23103-01-001

**Proposed Digital Enterprise Hub
and Residential Development at
Emmet Place, Nenagh,
Co. Tipperary**

ROAD SAFETY AUDIT STAGE 1

November 2023

2.1 Location: Parking provisions at digital enterprise hub and residential development

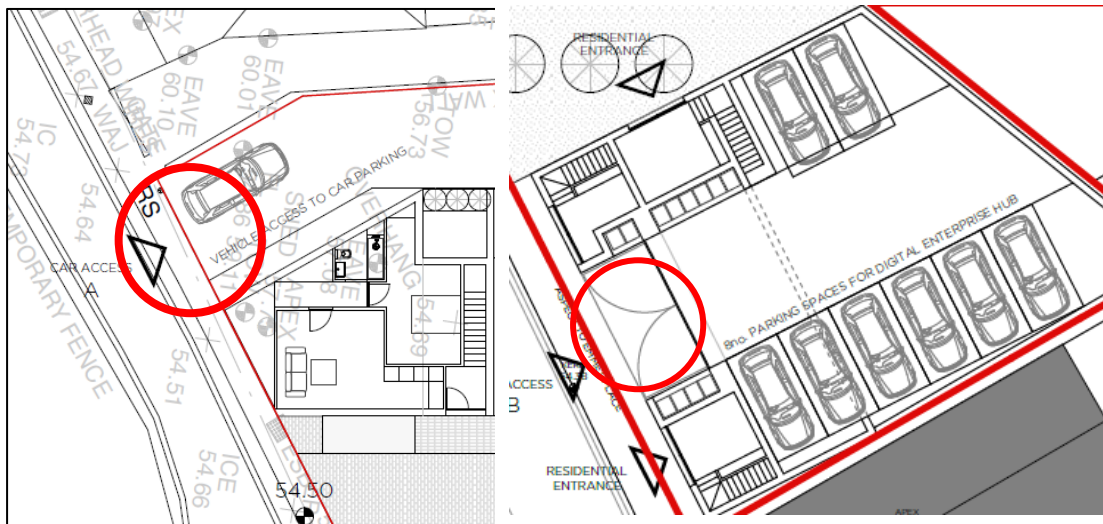
Parking facilities provided at the residential development and digital enterprise hub may be insufficient to cater for the expected number of users. This may force the users to park in undesignated areas such as on footpaths and could increase the risk of collisions with pedestrians if they are forced to travel along the carriageway.

Ensure adequate parking is provided.

2.3 Location: Residential development access road

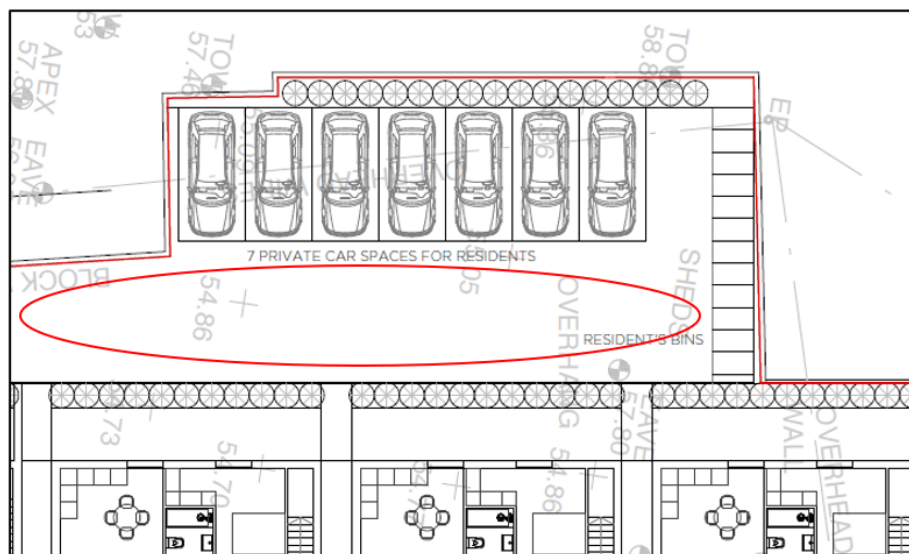
Bin storage for the residential is shown to be provided at the end of the access road. The collection strategy for bins has not been provided. The proposed access road appears insufficient to accommodate turning by refuse vehicles. Without adequate turning facilities, vehicles will be required to either reverse in or reverse out of the development. Reversing vehicles increases collision risk.

Provide a turning head sufficient for refuse vehicles if feasible or, if not feasible, implement a waste collection strategy which includes a methodology for safe refuse collection.
